Site Technical Query - Form

SN1809-0000/XE.FRM/0001 Rev 4 03/02/2021

Project:			
-A010- 0043	Oyu Tolgoi Underground Project			
y or on behalf of the Co	ntractor		•	
MCS International		Date Response Required: (dd/mm/yyyy)	06/13/2022	
Haulage Truck Work	shop /C-004D/	Plant Area & No:	1883	
CW2148472		Contractor TQ Number:	TWS-0415-TQ-0043	
datory) D1 (CSA) -	D2 (MP) - ⊠	D3 (E&I) - □ D4	(Other) - \square	
prinkler support mod sting cable tray, sprinkle 2F-001"-NI, 1883-FW-2	ification for servi er pipe support of 1 668-G2F-001"-NI,	ce bay 1 883-FW-2665-G2F-001"- 1883-FW-2669-G2F-001'		
Routine	⊠ Urger	nt Refer Technica	I Query instructions	
Due to the existing cable of M20 threaded rod with M20 threaded rod with ents 1 and 2 for more in The sprinkler support as 3-FW-2667-G2F-001"-I 2F-001"-NI will be modiful to attachments 3 and 4 modern to a mode	h hilti HIT-RE500-\ nformation. nd designed pipes NI, 1883-FW-2668- fied to design for th	/3 for support of sprinkler of 1883-FW-2665-G2F-0 -G2F-001"-NI, 1883-FW-2	pipe in Service Bay 1. Please 01"-NI, 1883-FW-2666-G2F- 2669-G2F-001"-NI and 1883-

ATTACHMENT 1. (DESIGN PROPOSAL 1)

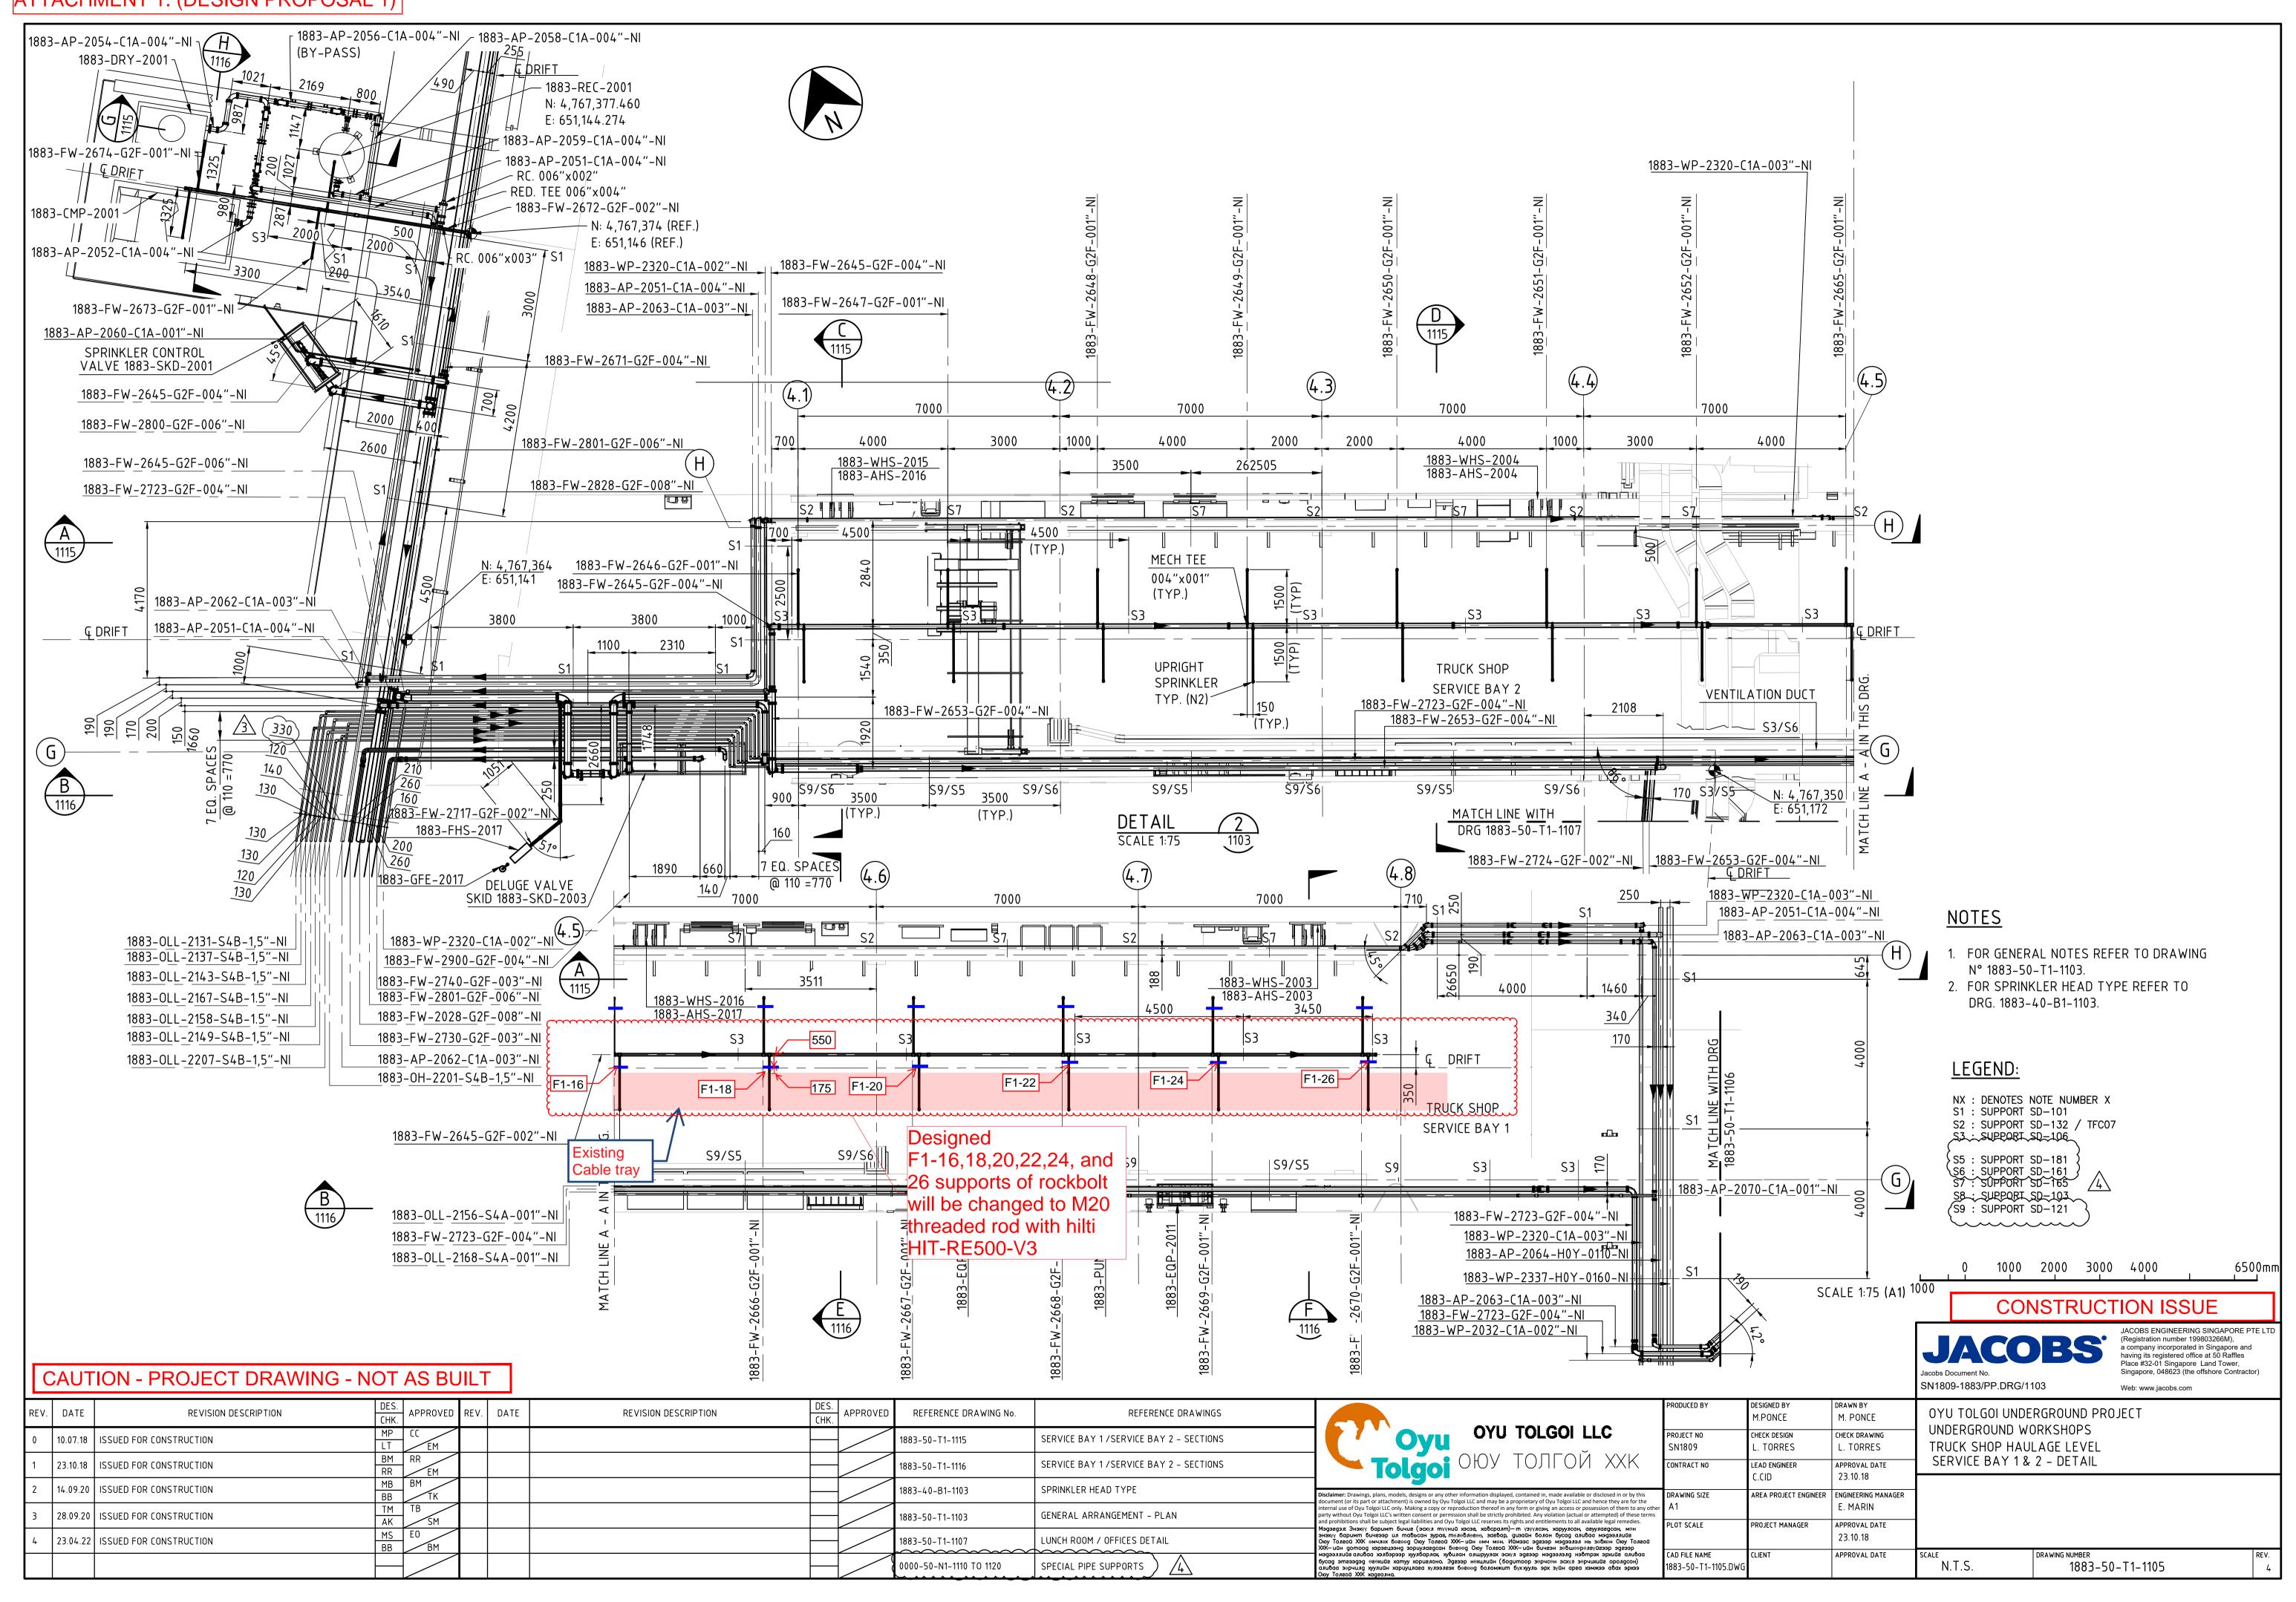
YES				
ays): NO				
NO				
z Zoljargal N.		Position:	MP Field engineer	
		Date: (dd/mm/yyyy)	06/10/2022	
	y or on behalf of the Co MCS International Haulage Truck Work CW2148472 Industry D1 (CSA) - Cal Query (List affected sprinkler support mode affected sprinkler support mode affected sprinkler support mode affected sprinkler support and cable tropostall around cable tropostall around cable tropostall around setting cable in M20 threaded rod with the sprinkler support and 3-FW-2667-G2F-001"-I2F-001"-NI will be modified to attachments 3 and 4 and 4 and 4 and 4 and 4 and 5 and 4 and 5 an	Haulage Truck Workshop /C-004D/ CW2148472 Industry D1 (CSA) - □ D2 (MP) - □ Cal Query (List affected drawings and spectorinkler support modification for service sting cable tray, sprinkler pipe support of 1 2F-001"-NI, 1883-FW-2668-G2F-001"-NI, 1883-FW-2668-G2F-001"-NI, 1883-FW-2668-G2F-011"-NI, 1883-FW-2668-G2F-001"-NI, 188	Oyu Tolgoi Undergr y or on behalf of the Contractor MCS International Date Response Required: (addmm/yyyy) Haulage Truck Workshop /C-004D/ CW2148472 Contractor TQ Number: Indiatory) D1 (CSA) - □ D2 (MP) - □ D3 (E&I) - □ D4 Cal Query (List affected drawings and specifications): Interprinkler support modification for service bay 1 Sting cable tray, sprinkler pipe support of 1883-FW-2665-G2F-001*- D1 install around cable tray that already exists. CRoutine □ Urgent Refer Technical all attachments) Due to the existing cable tray, the contractor proposes that the design M20 threaded rod with hilti HIT-RE500-V3 for support of sprinkler ents 1 and 2 for more information. The sprinkler support and designed pipes of 1883-FW-2665-G2F-001*-NI, 1883-FW-2668-G2F-001*-NI, 1883-FW-2687-G2F-001*-NI, 1883-FW-2689-G2F-001*-NI, 1883-FW-2689-G2

<u>Proposed option#1 is accepted with following comments due to live cables</u> and independence of piping support,:

- The substitution of M25 rock bolt is acceptable subject to provision of M24 grade 8.8 HDG anchor rods with Hilti HIT RE-500 adhesive and proof/pull test at 45 kN;
- 2. Anchor rod embedment shall be 700 mm min into sound rock and projection to suit in the field;
- Contractor shall be considered to keep clearances in between support chain and cable tray according to site standard and requirements. Should not be touched with each other;
- 4. Redline the related drawings accordingly.
